## EXPLANATIONS

- The way the questions were written was not interfered.
- English specifications is updated; in chapter “Deliverables”, the summary will be submitted as a vertical A1 sheet.
- Drone videos are shared in the competition website.
- In “soru\_yanit\_ekleri\_questions\_answers\_appendices” file,
  - Static project of the fill area is uploaded as “11\_Dolgu\_Statik\_Proje\_Fillarea\_Static\_Project”,
  - Information and documents for registered assets are uploaded as “12\_Tescilli\_Yapi\_Registered\_Assets”.
  - An aerial image of the Square is uploaded as “13\_Meydan\_Hava\_Fotograf\_Aerial\_Photo\_of\_the\_Square”.
- Questions received have been grouped under the titles as below:
  - A- QUESTIONS ABOUT ELIGIBILITY
  - B- QUESTIONS ABOUT SPECIFICATIONS, INFORMATION AND DOCUMENTS
  - C- QUESTIONS ABOUT SUBMISSION AND SUBMISSION RULES
  - D- OTHER
  - E- QUESTIONS RECEIVED IN ENGLISH\*

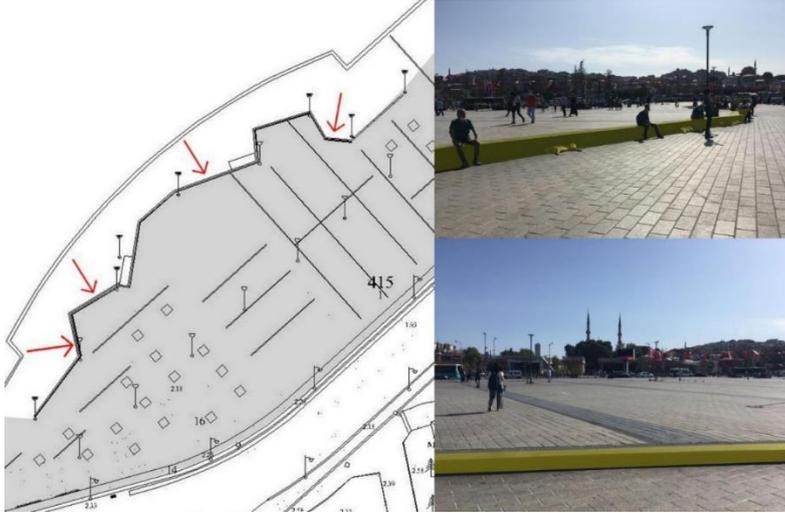
36. Will we accept the square and the 3-storey bazaar adjacent to Mimar Sinan Bazaar, which is currently under construction by Üsküdar Municipality, is it possible to intervene in this area?

It is expected to design considering the current situation of the site and the ownership.

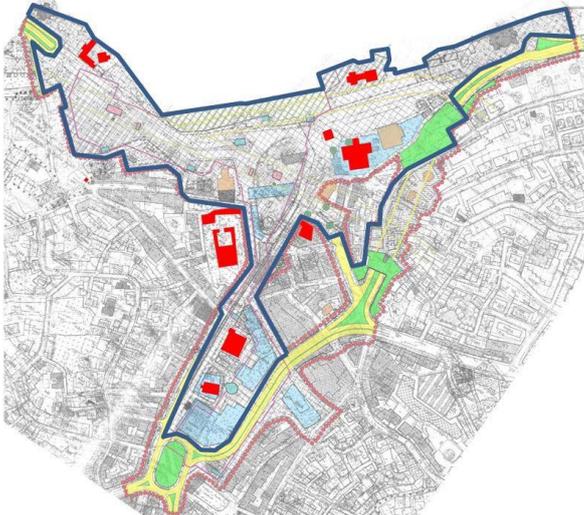
96. To confirm if the area marked by the blue color boundary will be converted into a Pedestrianized zone. If the marked area is Pedestrianized, is there an existing design in place that can be referenced or are we free to propose.

Area that is blue marked by the competitor does not represent pedestrianized area. Specification appendices "3\_Imar\_Plani\_Master\_Plan" is valid. However, implementation is not planned.
